CF 10960
R-10151
10151-A

RE: Injection Pressure Increase Quercho Plains Queen Associated Waterflood Project in Lea County, New Mexico

Re: Application for Increased Surface Injection Pressure
Querecho Plains Queen Associated Waterflood Project
Lea County, New Mexico

STEP RATE TEST
FEDERAL "E" No. 9

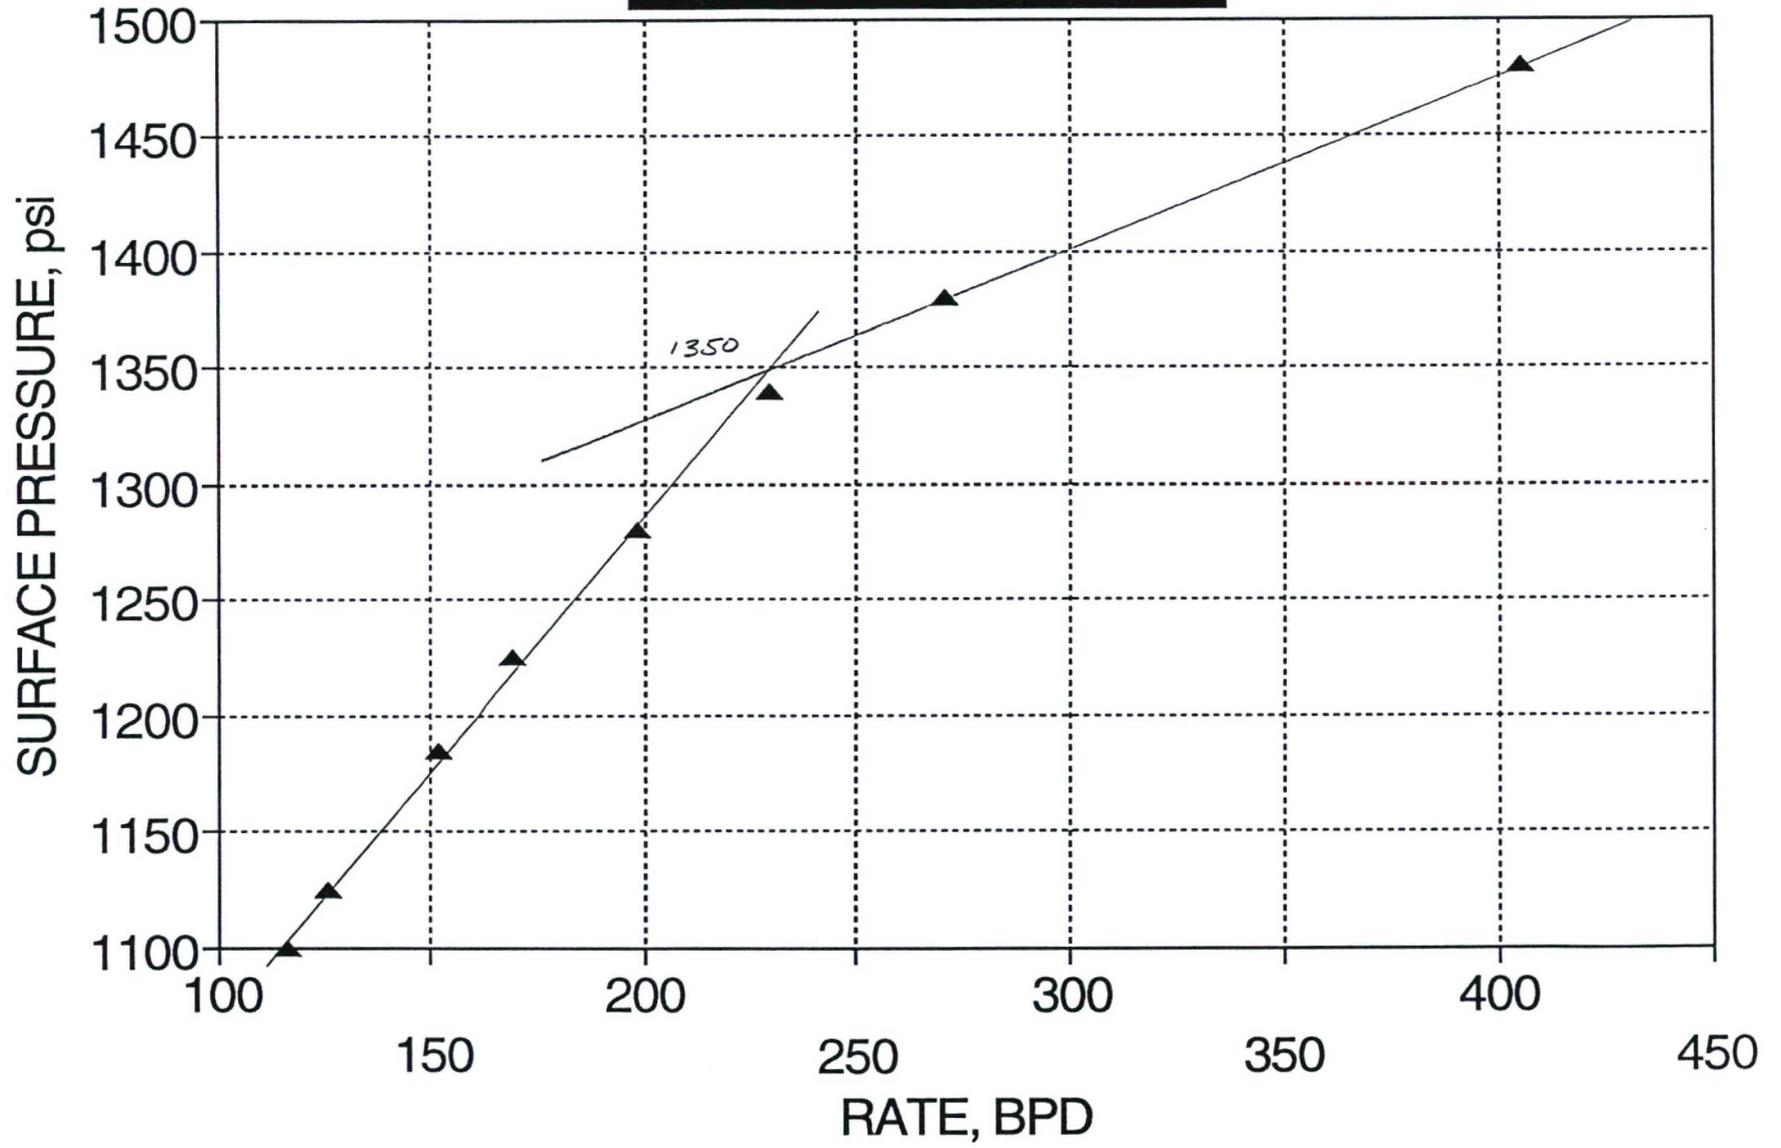
Reference is made to your request dated July 14, 1995 to increase the surface injection pressure on all ten wells which comprise the above referenced waterflood project. This request is based on a step rate tests conducted in May and June, 1995 as well as additional pressure data. The results of the test and inferences of the data have been reviewed by my staff and we feel an increase in injection pressure on these wells is justified at this time.

Mewbourne Oil Company requests administrative approval to increase surface injection pressure to 1350 psi at the referenced waterflood. In support of this request you should find attached: 1) Exhibit 25 from the original waterflood hearing which documents the ISIP of fracture treatments for all wells in the field, 2) Step rate tests, conducted in May/June 1995, from five of the ten existing injectors, and 3) Reference to Finding No. 9 from Division Order R-10151 suggesting the Division Director should have administrative authority to approve this increase. The attached step rate tests have water gravity, depth to top perforation, and friction pressure taken into account. In addition, diligent care was taken to keep the time period between each data point consistent throughout the tests.

You are therefore authorized to increase the surface injection pressure on the ten initial wells in the Quercho Plains Queen associated Waterflood Project which were authorized by Division Order R-10151, to **1350 psig for each well**. If the subject project is expanded to include additional wells by an administrative order in the future, those wells will be subject to the originally authorized injection pressure of 777 psig until such time that other data warrants a respective increase.
